SJ58; CROSSRAIL MODIFICATION FRONT SHEET

MODIFICATION No	SJ58/GEN/	GEN/M/063 Page 3		1 of 2		
INDEX (1) VERSION:	N/A					
PLACE:	Signalling S	Signalling Scheme Plan – Area 6 East of Plumstead Portal				
DESCRIPTION OF WORK	Updated to C	RL comments				
SCHEME PLAN NUMBER:	C620-SIC-R2-	DDE-CR001-00005	Rev: FG	Revision		
UPDATED SHEET NUMBER C620-SIC-R2-DDE-CR001-	RS: Revision	Company to the second control of the second control of	UPDATED SHEET NUMBERS: C620-SIC-R2-DDE-CR001-			
00005	FG			-		
Supporting Paperwork:	√	Designer/Chr	ecker/Annr	over to note here if any

MODIFICATION No		SJ58/GEN/N	1/073	Page 1 of 2	2	
INDEX (1) VERSION:		N/A	I			
PLACE:		Area 6 Signalling Scheme Plan updates				
DESCRIPTION OF WOR	RK	Updated to SJ5	8/CCF/0665			
SCHEME PLAN NUMBE	ER:	N/A		N/A		
UPDATED SHEET NU C620-SIC-R2-DDE-CF	JMBERS:	Revision	UPDATED SHEET NUMBERS: C620-SIC-R2-DDE-CR001-			Revision
00005 (Area 6)		FH

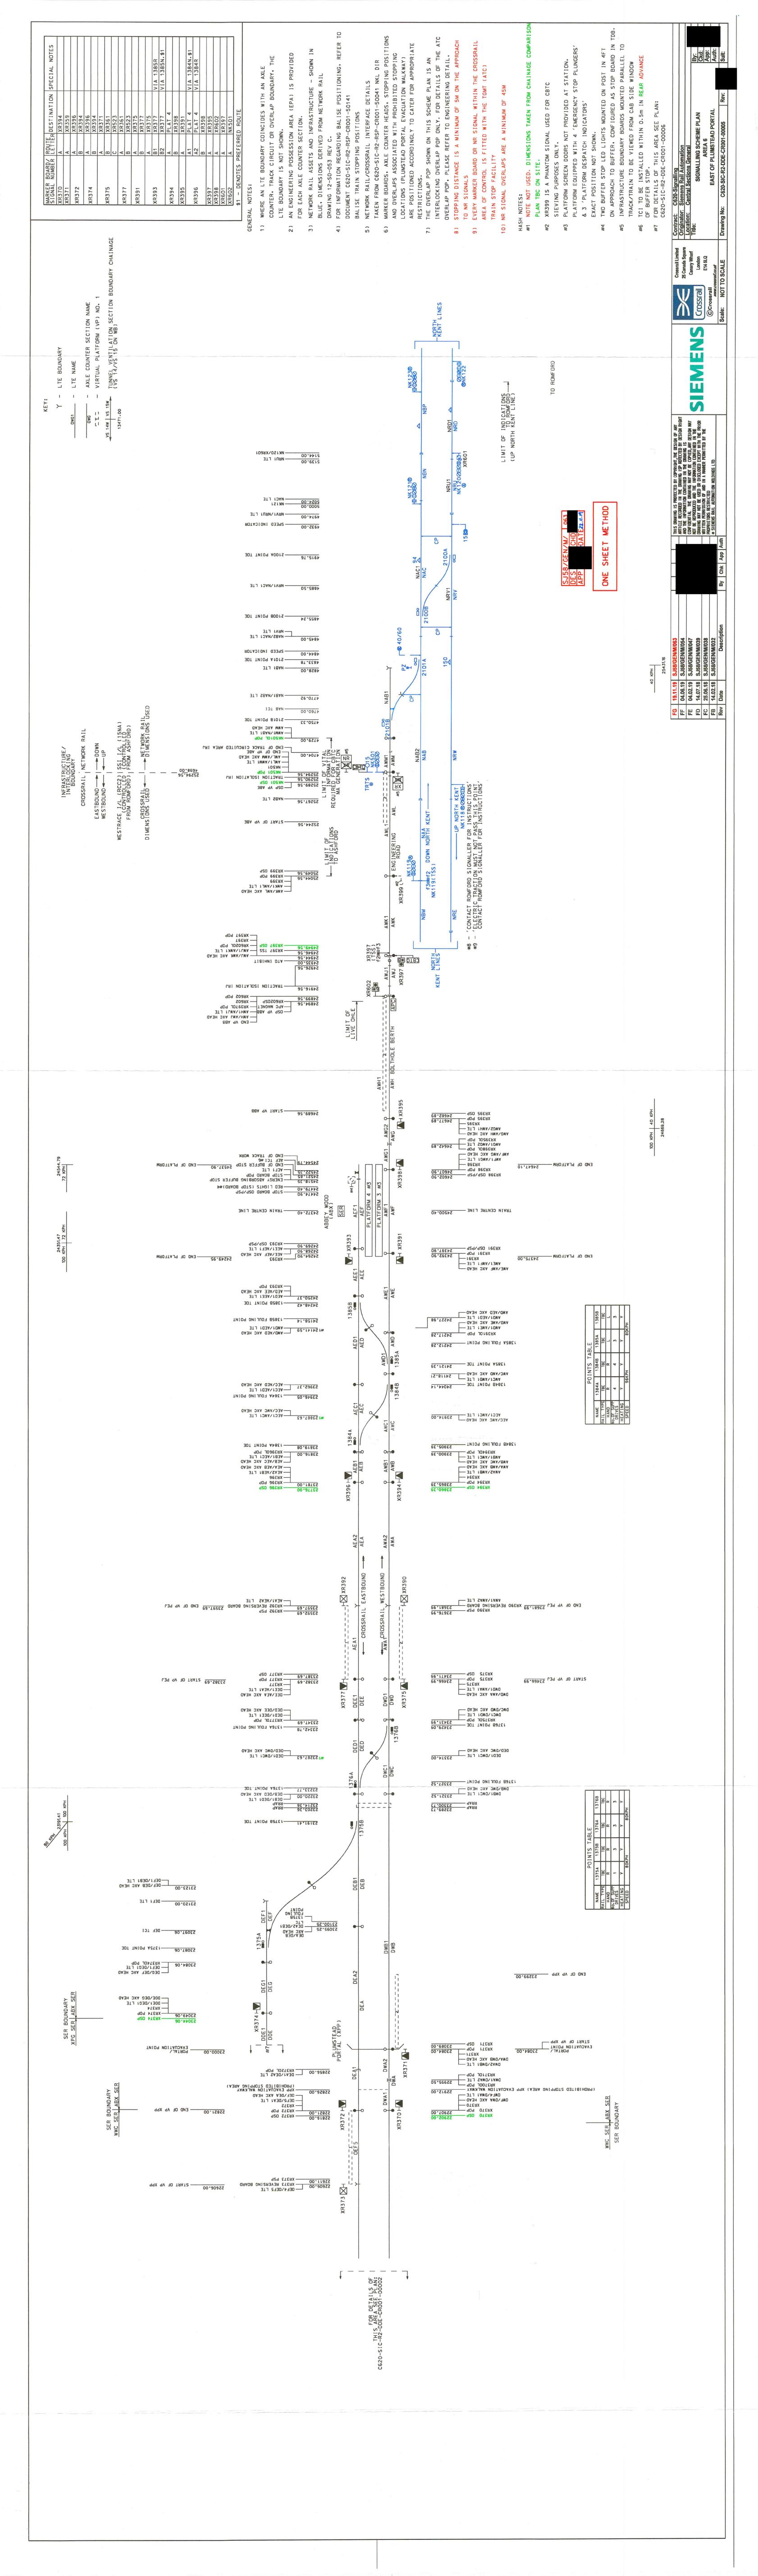
MODIFICATION No	SJ58/GEN/M/063 Page 1 of 2		Page 1 of 2	2	
INDEX (1) VERSION:	N/A				
PLACE:	Signalling Scheme Plan – Area 6 East of Plumstead Portal				
DESCRIPTION OF WORK	Updated to CRL comments				
SCHEME PLAN NUMBER:	C620-SIC-R2-DDE-CR001-00005 Rev: FG				
UPDATED SHEET NUMBERS: C620-SIC-R2-DDE-CR001-	Revision	UPDATED SHEET N C620-SIC-R2-DDE-	Revision		
00005	FG				
			-		
		4
